WEST HAVEN CITY
PLANNING COMMISSION AGENDA

NOTICE IS HEREBY GIVEN THAT ON DECEMBER 14, 2022 THE WEST HAVEN PLANNING COMMISSION WILL HOLD THE FOLLOWING PUBLIC MEETINGS: 5:00 PM WORK SESSION 6:00 PM REGULAR PLANNING COMMISSION MEETING. JOIN US DIGITALLY ON ZOOM HTTPS://US06WEB.ZOOM.US/J/86539464549 OR WATCH US LIVE ON YOUTUBE AT HTTPS://WWW.YOUTUBE.COM/CHANNEL/UCEEQNQBTFZJWTGOPHMCNCBA

Planning Commission
Staff Review Memo

Planning Commission
Staff Review Memo

SITE PLAN

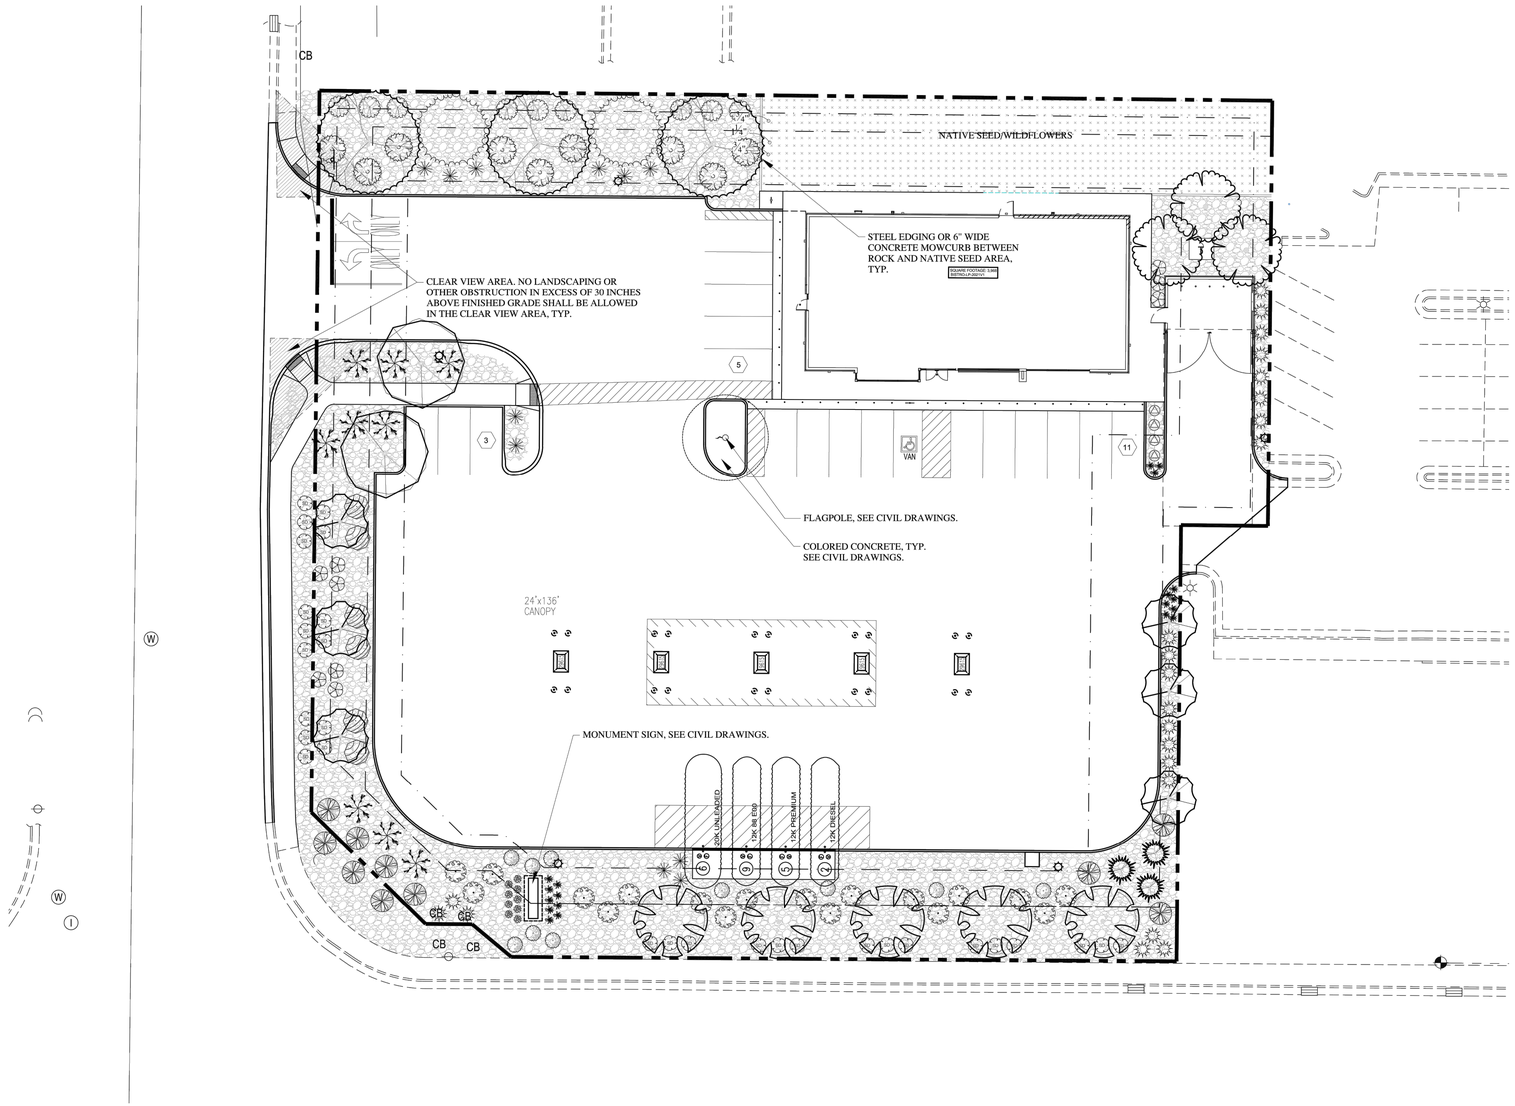
The closest use that is specified is a retail store, which requires 1 space per 200 square feet of floor space in the building. This standard would require 19 parking spaces on the site. ***The site plan proposes 19 total parking spaces. This satisfies the requirement and intent of the parking regulations.***

(1) Does the site plan comply with the West Haven City Engineering Design Standards and Specifications related to traffic ingress, egress and internal circulation? ***At the preliminary level, the site plan complies. There is no access proposed on to 4000 South, so no coordination with UDOT is required. As the final civil documents are prepared, the applicant will be required to make any minor modifications necessary to ensure the site is consistent with City standards.***

PRELIMINARY LANDSCAPE PLAN

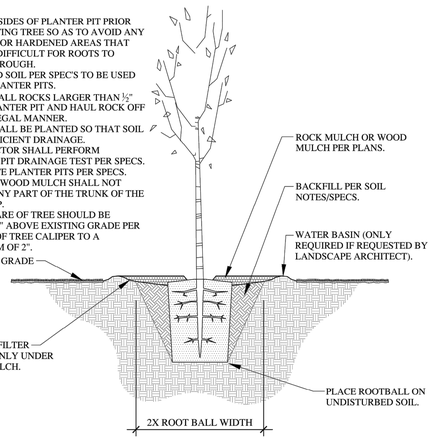
Page 5/12 (landscaping plan) provides that the project will have trees, decorate rock and boulders, shrubs and grasses. This requirement has been satisfied.

South Elevation
NTS

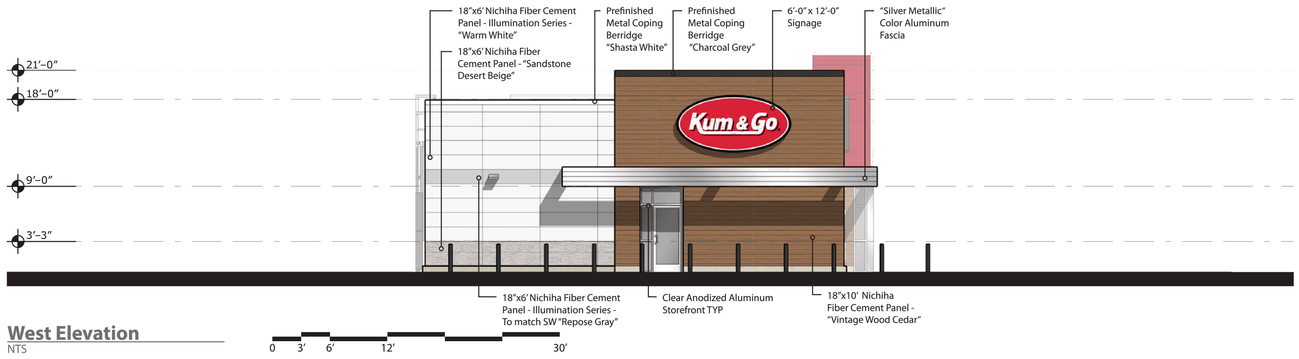
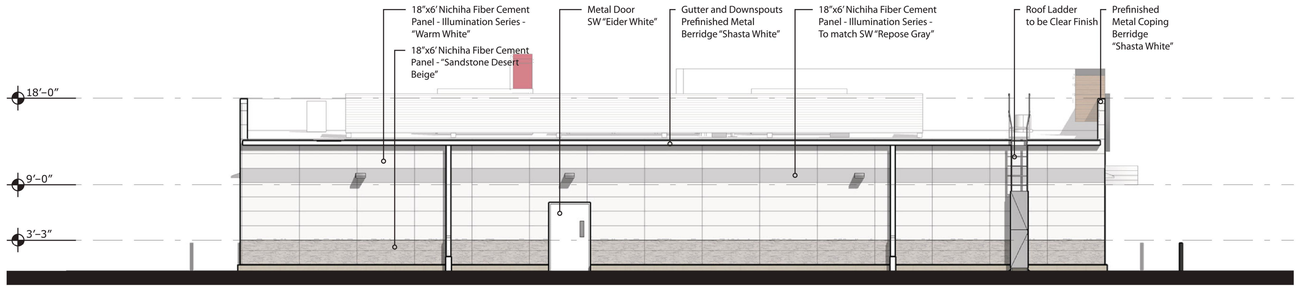
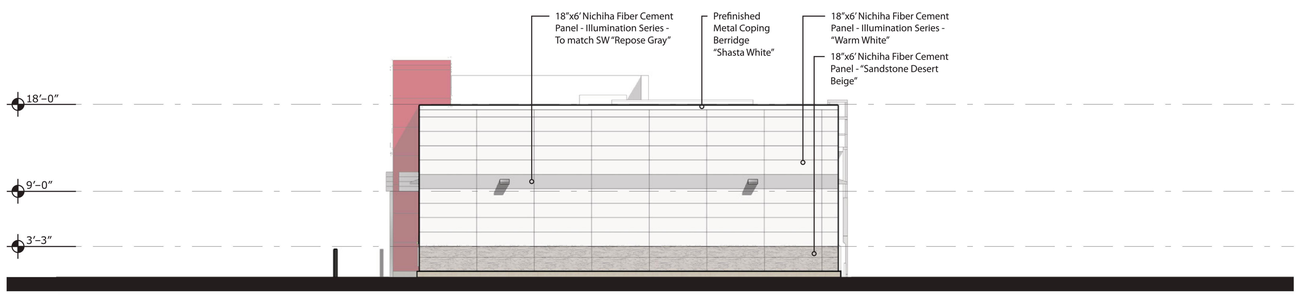
(1) All buildings shall be designed with breaks in the facade. This may be accomplished through a change in building materials, actual breaks in the facade, a mix of roofline projections. ***There are breaks in the façade of the proposed building. The breaks are accomplished by several things- projections, varying building heights, change in materials, inclusion of windows. This requirement has been satisfied.***

- **Prior to final approval, the applicant shall provide the City with the following:**
    - **A will-serve letter from the Hooper Water Improvement District**
    - **Finalized elevations showing the distribution of architectural materials across the building to ensure compliance with the design criteria.**

B 8' MONUMENT SIGN
NOT TO SCALE

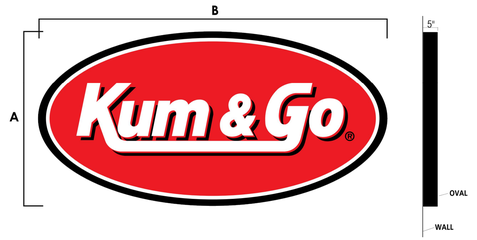
Because this is a standalone project rather than part of a commercial complex, it is a considered a "freestanding commercial" monument sign. The monument sign regulations for such are as follows (see sheet 11/12 of submittal docs for proposed sign design):

300-599 Linear Ft. Frontage	Requirement	Site Plan Proposal	Compliant
Max. area per sign face	65'	64'	Y
Max Height	8'	8'	Y
Max # of Signs	1	1	Y

1 PRELIMINARY SITE PLAN

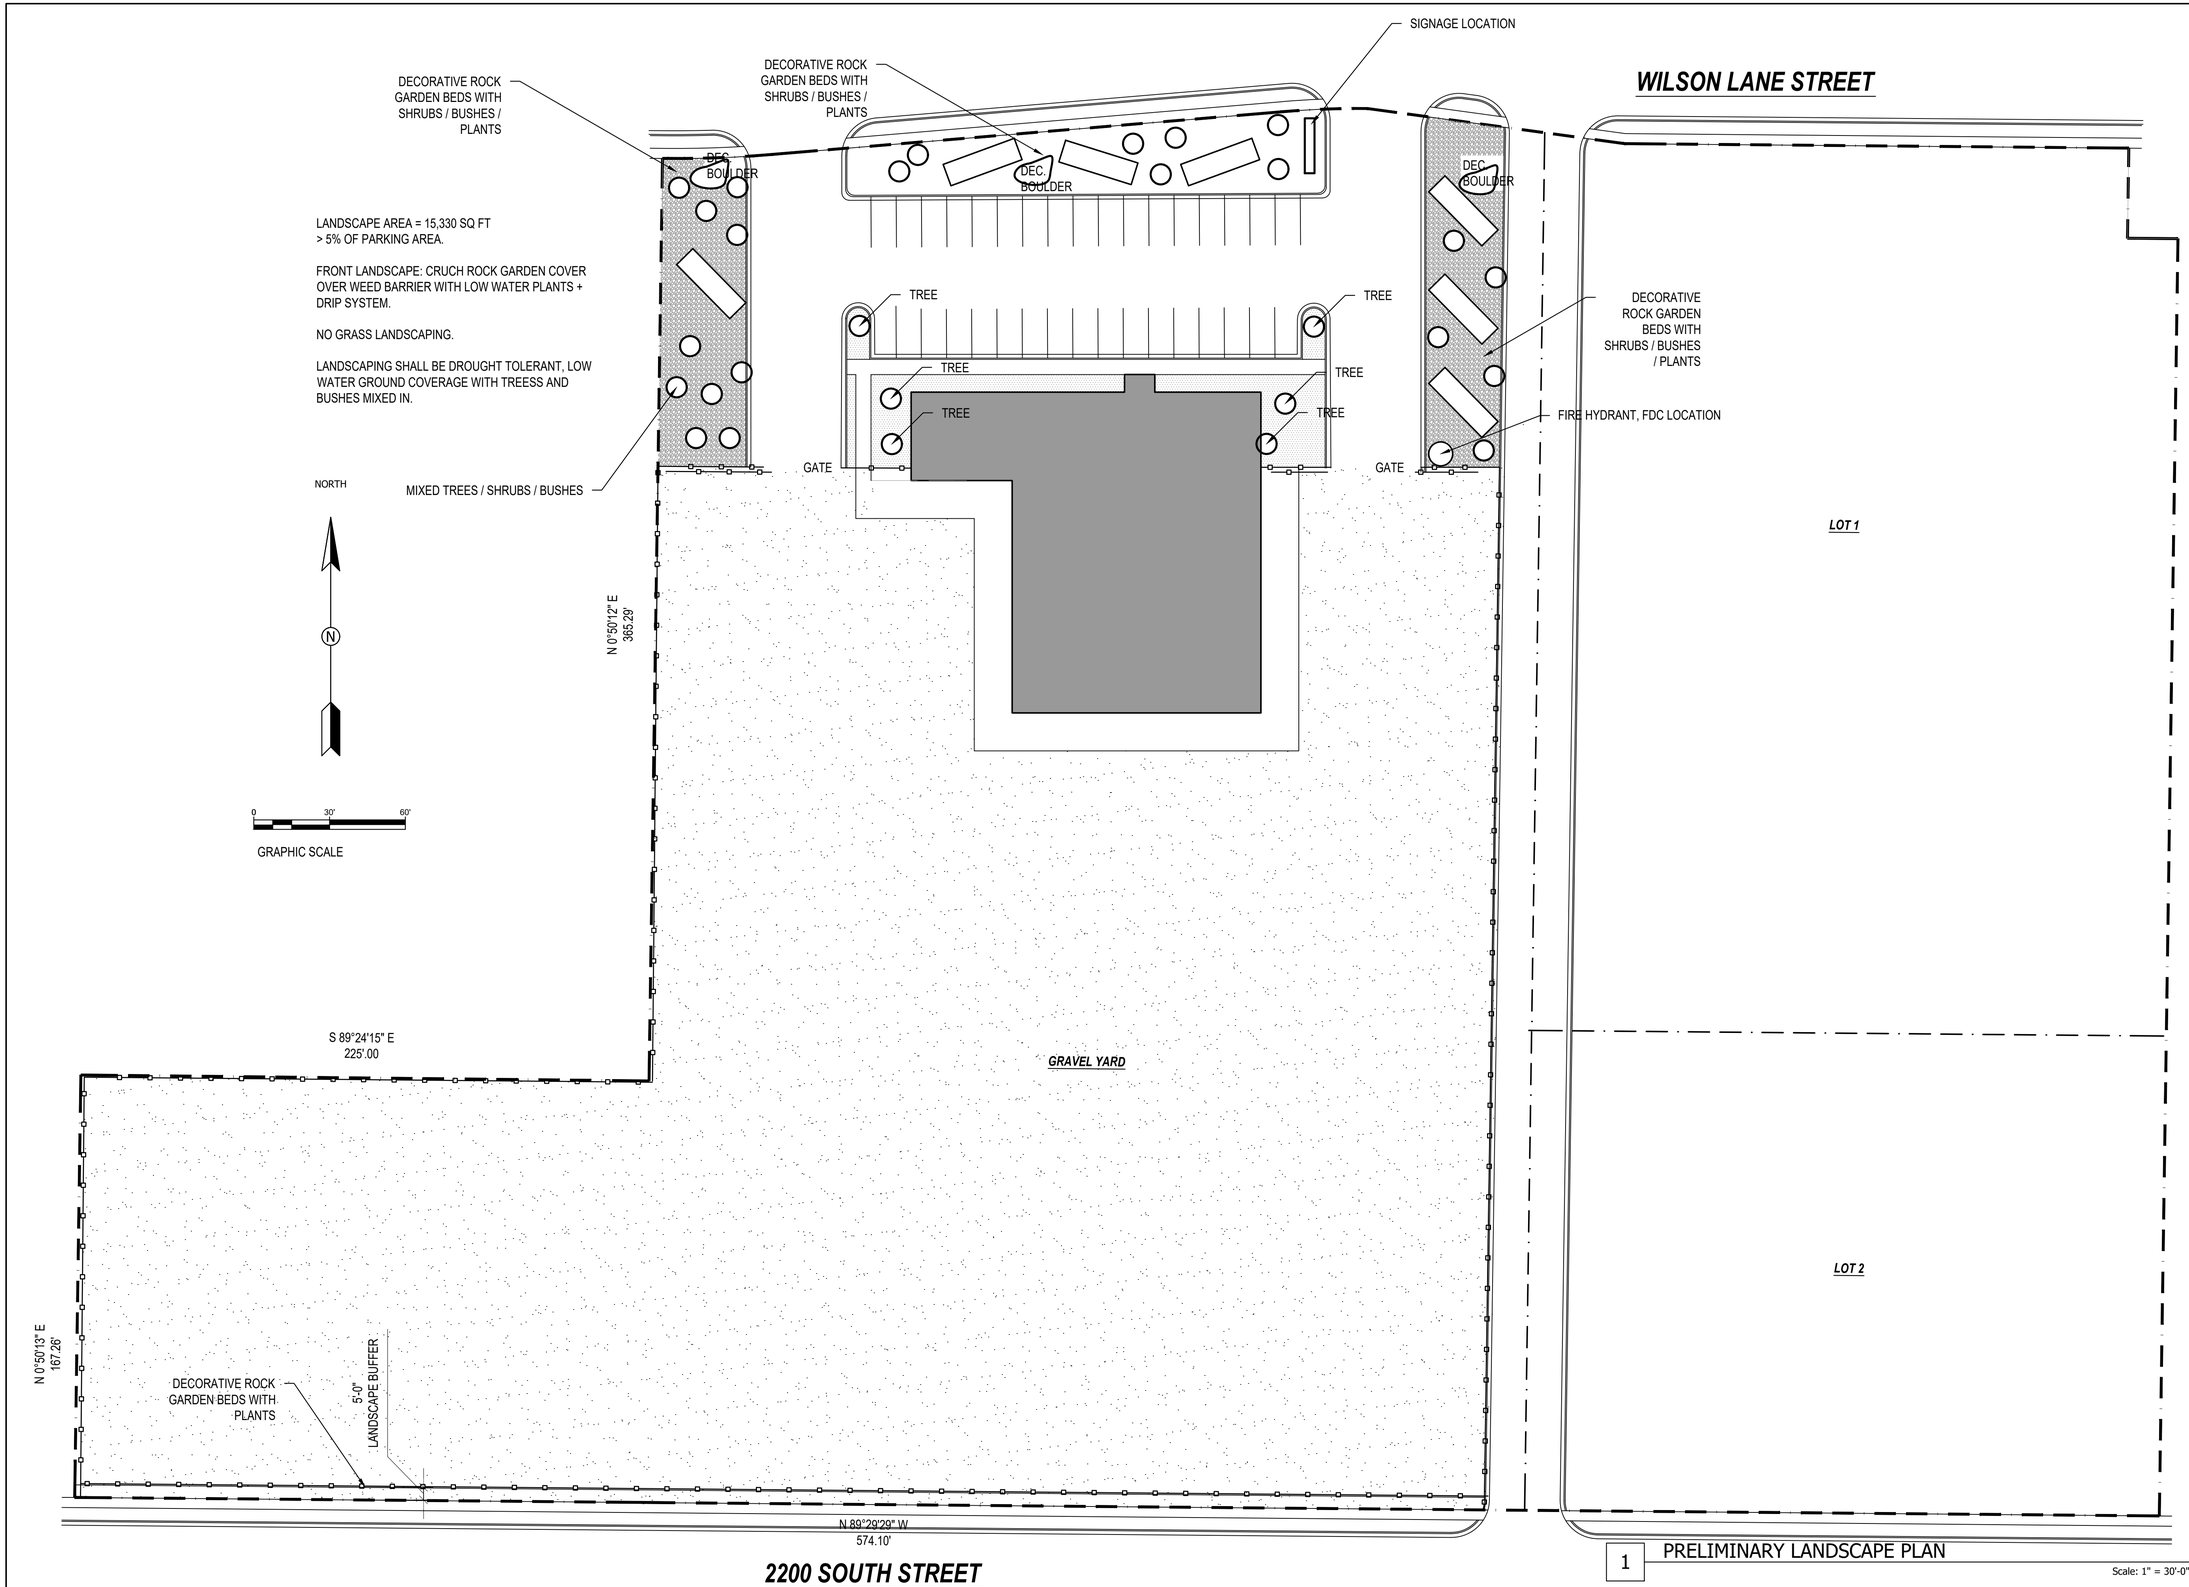
1- They do not have an approved set of civil drawings
   a. These are in the process of being reviewed. The applicant has been made aware that no permits for site improvements will be issued until the City Engineer has approved and stamped the civil drawings.
2- The sign that they are proposing (a pole sign) is not a permitted sign type in the C-2 zone. There are pole signs in various C-2 zones throughout the City, but pole signs were omitted (inadvertently, I believe) when the City redid its sign code in 2021.

a. John Deere requires Honnen to have JD specific signs, as part of JD's branding. Regardless of the commercial zone that Honnen is in, JD dictates the signage they need to have.

BOUNDARY DESCRIPTION

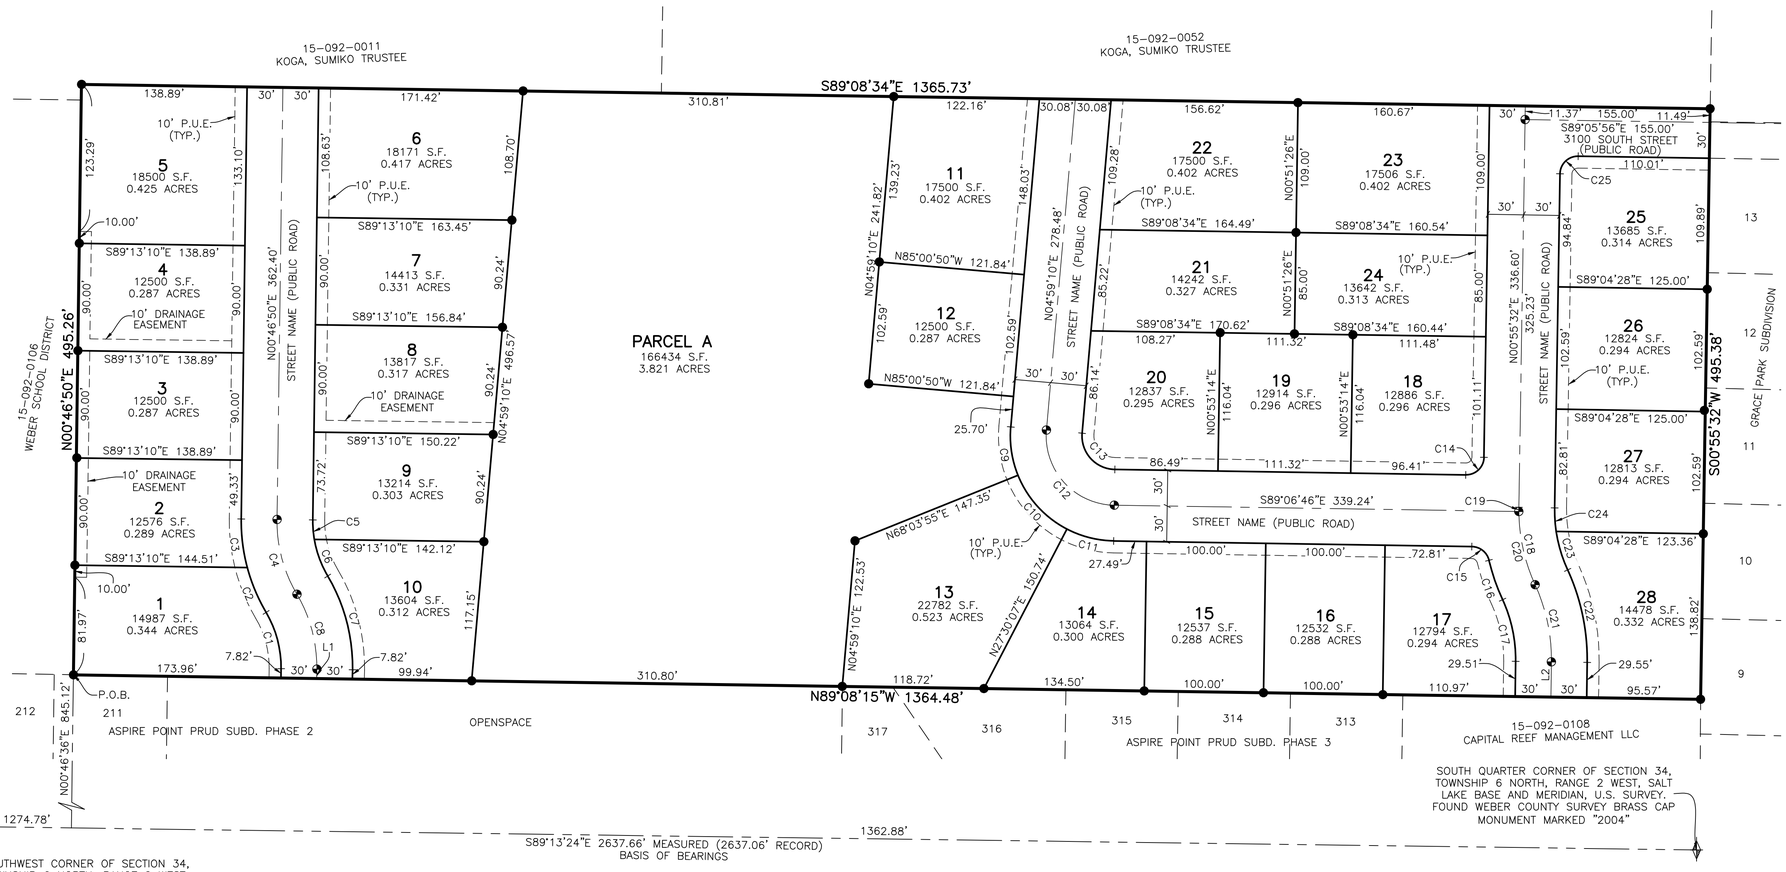
- The final plat does not show a public trail on the property, which was a condition of approval put into place by the West Haven City Council on May 4, 2022
- The temporary turnarounds have not been shown on the final plat, as required by community development and engineering staff.
- The final plat does not have street coordinates to those roads which will service the development, as per City engineering standards.
